ADDENDUM TO THE CONTRACT DOCUMENTS

ADDENDUM No.: 3

DATE : 9/4/15

PROJECT: New Town Hall
Construction Project
26 Court Street
Plymouth, MA

SOUND ATTENUATOR SCHED. REVISION

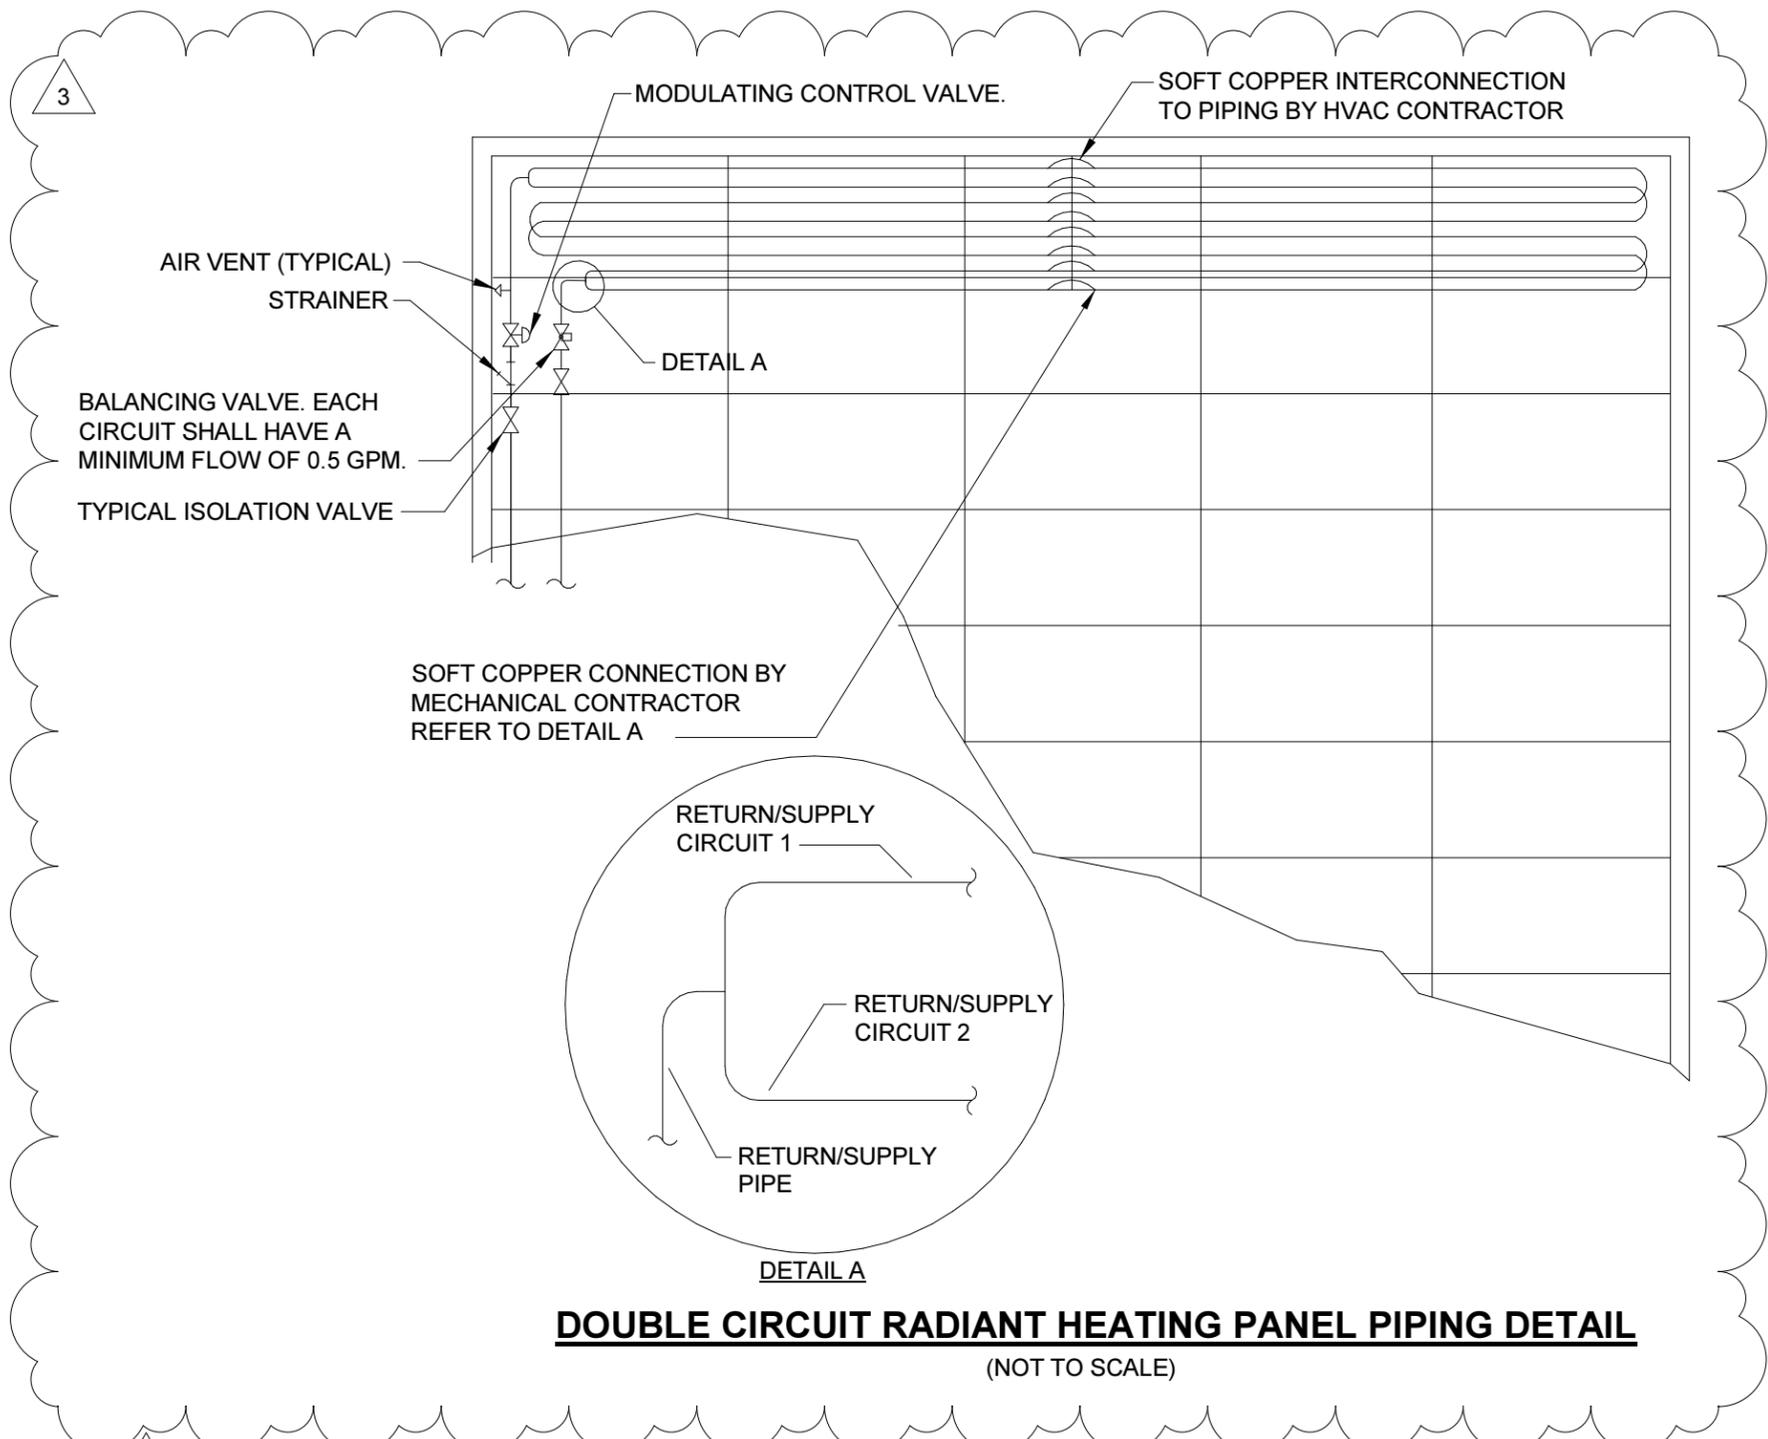
Drawing No.:	Description:
Mechanical	
M301	<ol style="list-style-type: none"> 1. Exhaust Fan Schedule: ADD note that reads, "Provide Magnetic Bearing Protection for EF-1 & EF-8." 2. Air Handling Unit Schedule: ADD note that reads, "All controls shall be provided by ATC Contractor, refer to specification for further info." 3. Radiant Heating Panels Schedule: REVISE note to read: "Selection based on "Price, 160° EWT, 20° WTD, 35% Propylene Glycol Concentration by weight. Refer to drawings for panel length. Confirm mounting locations with Architect. Provide end-cap trim on each side of panel for a continuous look wall-to-wall, provide mounting arm for RPLS models. Provide dual circuits with low-loss headers for panels that exceed 4 feet of head on pressure drop. Provide trim panels for seamless appearance." 4. Water Pumps Schedule: DELETE note in its entirety, "Hot & Chilled Water Pumps are sized for future training room addition, current design GPM's are 95 for chilled water & 90 for hot water." 5. Hot Water Boiler Schedule: DELETE note in its entirety, "Boiler Plant sized for future service of training room addition." 6. Sound Attenuator Schedule Revision, Refer to Sketch SKM-015.

2 AUTOMATED LIGHTING CONTROL SYSTEM ALCS ONE-LINE DIAGRAM
 SCALE: N.T.S.

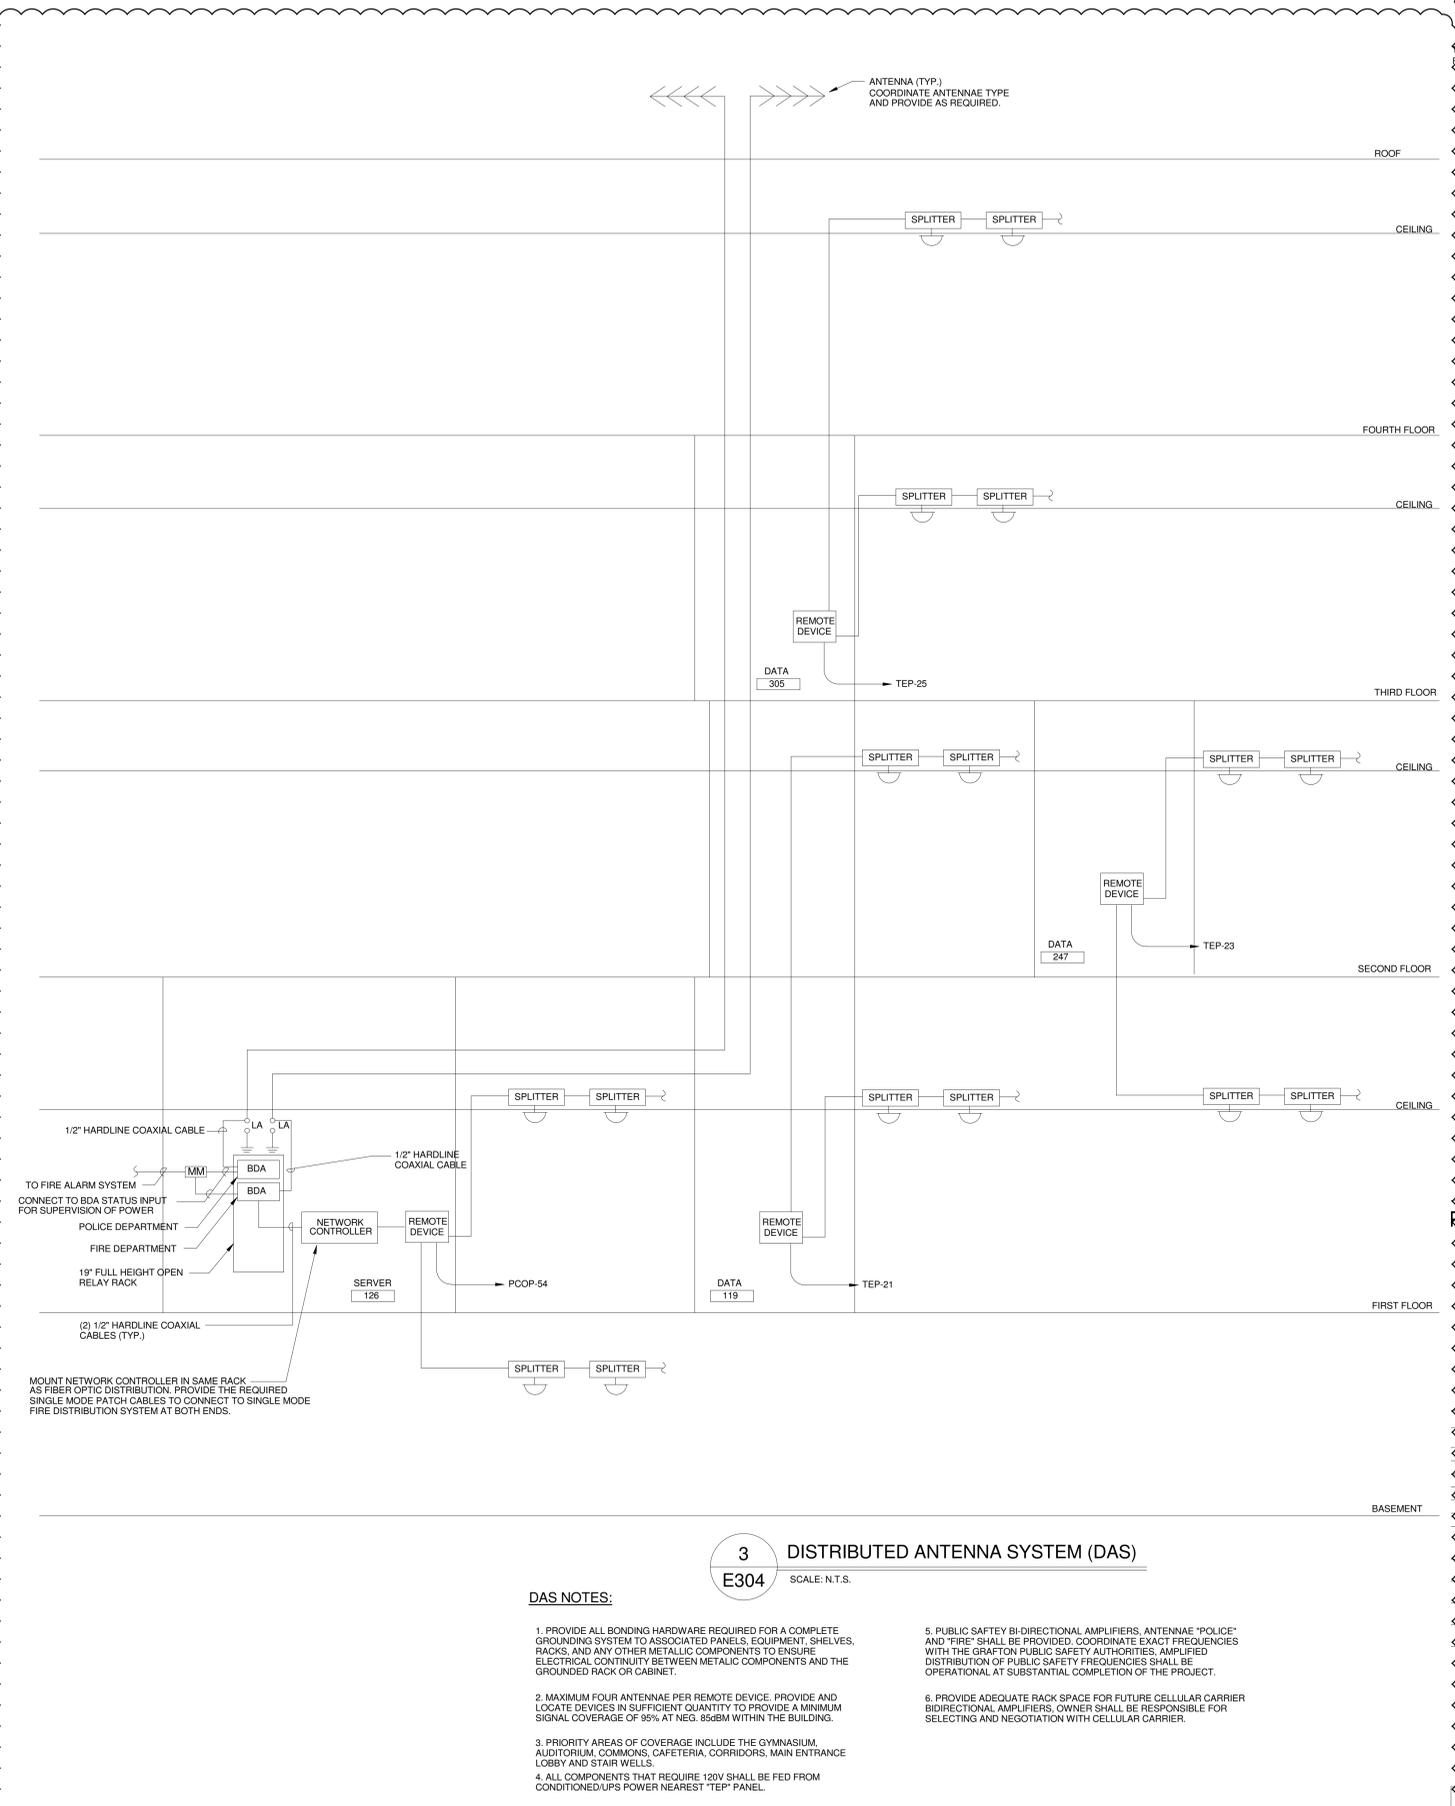
E302	ADD to main switchboard schedule on Line 1 remarks column: "100% rated with GFI protection."
E303	Incorporate the following changes and/or revisions on the following sketch: SKE-011.
E304	ADD Detail 3/E304 Distributed Antenna System DAS. Reissue sheet E304 in its entirety.
E405	Incorporate the clarifications and/or revisions on the following sketch, SKE-021.
FA001	Incorporate the clarifications and/or revisions on the following sketches: SKE-016 and SKE-017.
FA100	<ol style="list-style-type: none"> 1. ADD smoke detector in Stair A. 2. ADD (3) smoke detectors in Room Archives 007. Refer to SKE-018. 3. Relocate pull station, speaker/strobe and add smoke detectors in existing building, refer to sketch, SKE-018.
FA101	<p>Revise the following items:</p> <ol style="list-style-type: none"> 1. DELETE speaker strobe in Room 127. 2. RELOCATE radio master box to Room 127 adjacent to fire alarm control panel (FACP). 3. REMOVE smoke detector in Room 128. 4. ADD weatherproof speaker/strobe in areaway. 5. ADD strobe only device in Room 142. 6. ADD smoke detectors at bottom of Stairs D & E.
